**TOWN OF WINTER PARK
PLANNING COMMISSION**
Tuesday, June 11, 2024 8:00 AM

TO Planning Commission
FROM James Shockey, Community Development Director
DATE June 11, 2024
RE Minor Site Plan Lots 1-5, Block 9, Roam Filing No. 1

Wilds360 Phase II Minor Site Plan Application Narrative

1 1st Level Floor Plan
 SCALE: 1/4" = 1'-0"

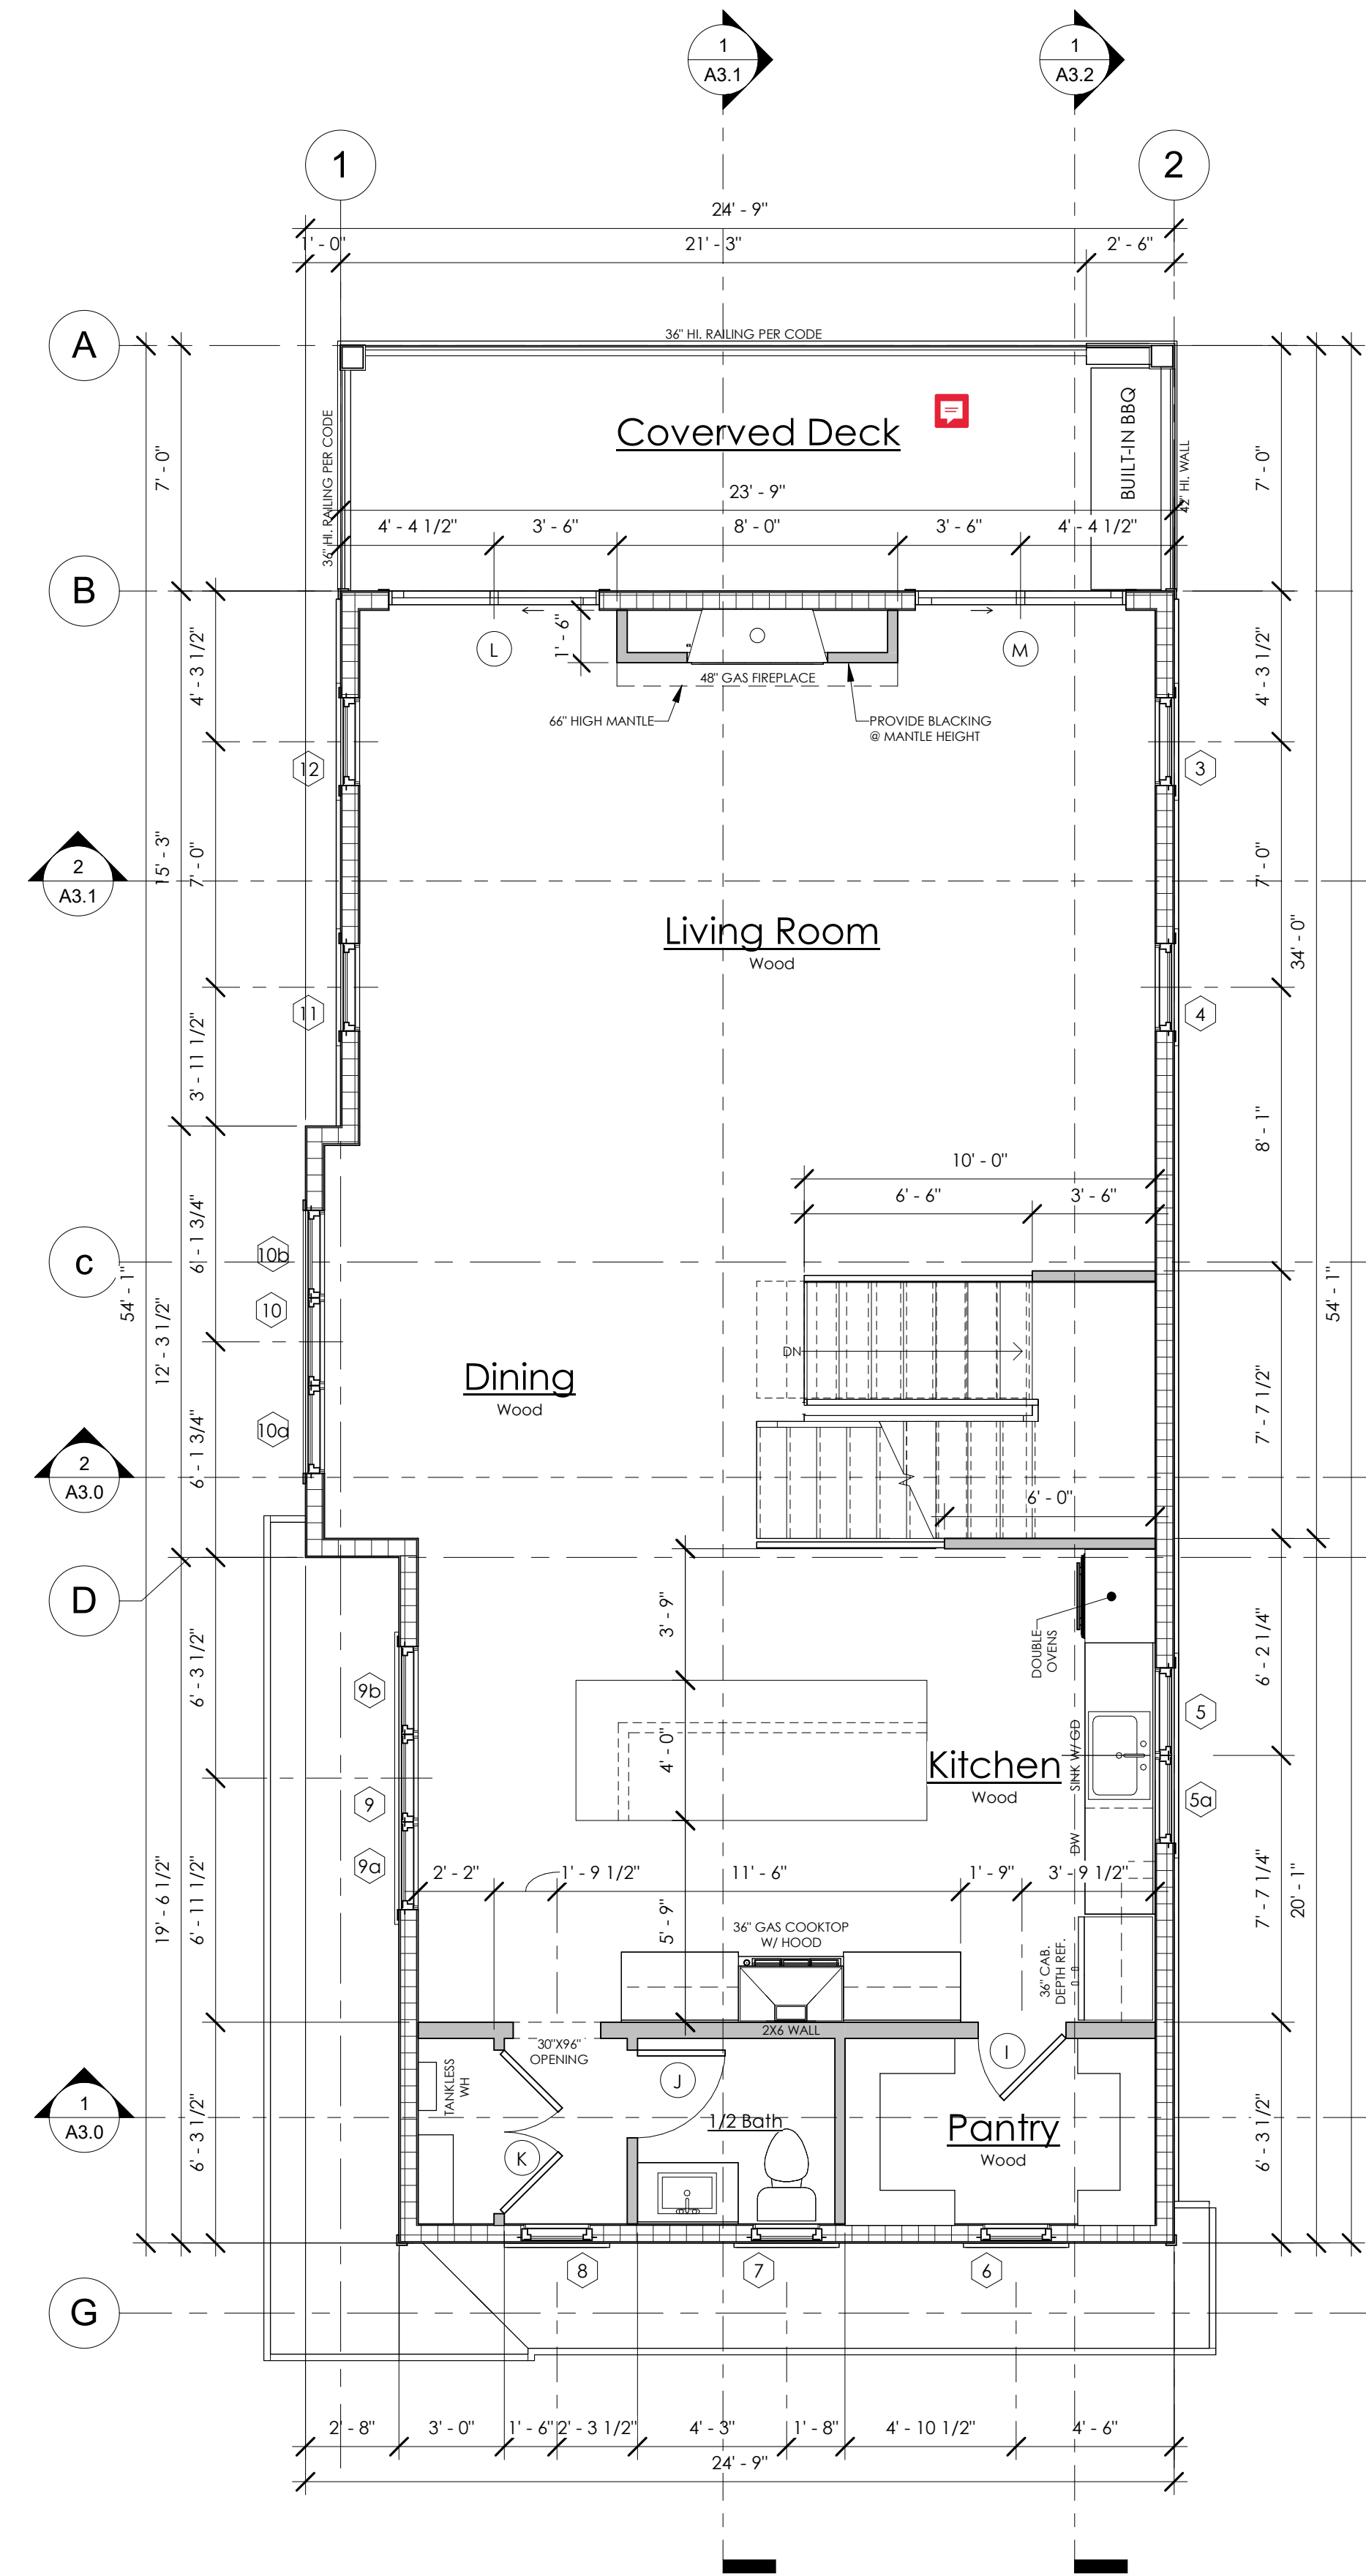
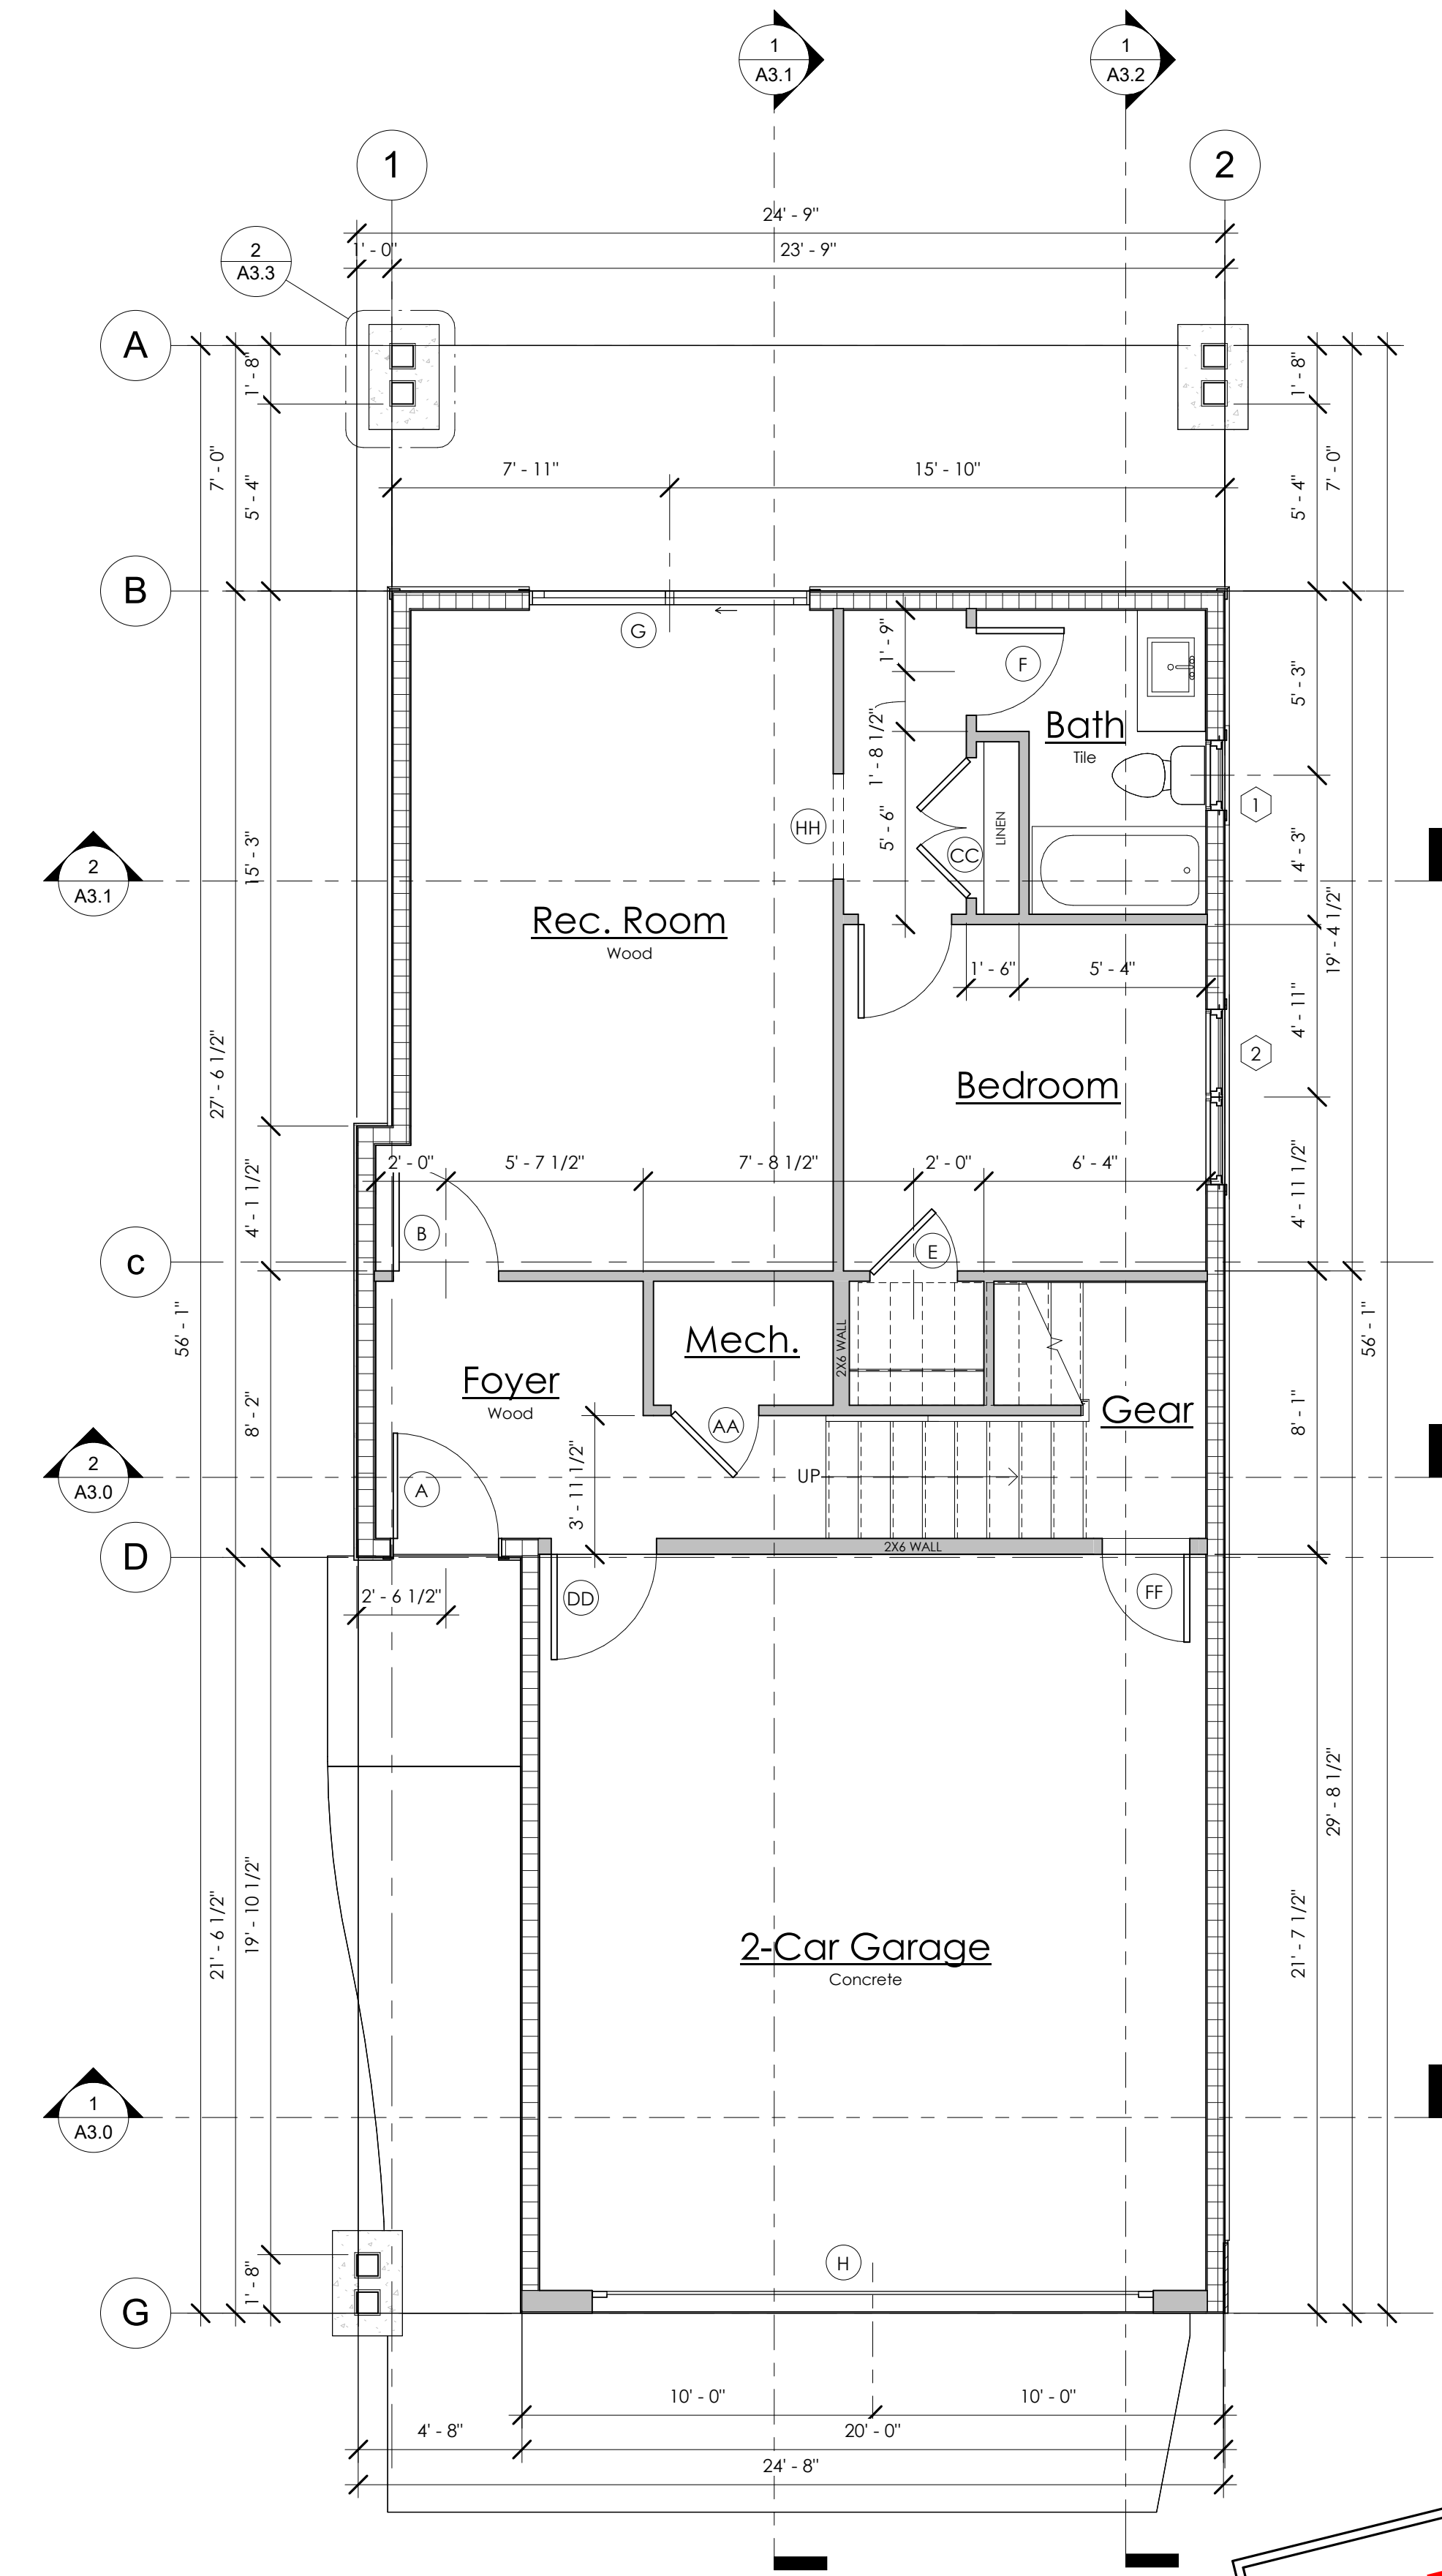
Unsatisfactory. The Floor Plans for Lots 1-5 do not provide the total square footage. On Lot 1, the word “covered porch” is misspelled in the Floor Plan.

- The applicant shall indicate the total square footage as well as the square footage for each room.
- The applicant shall correct any misspelled notes in the Floor Plans.

5. The applicant shall indicate the total square footage as well as the square footage for each room.
6. The applicant shall correct any misspelled notes in the Floor Plans.
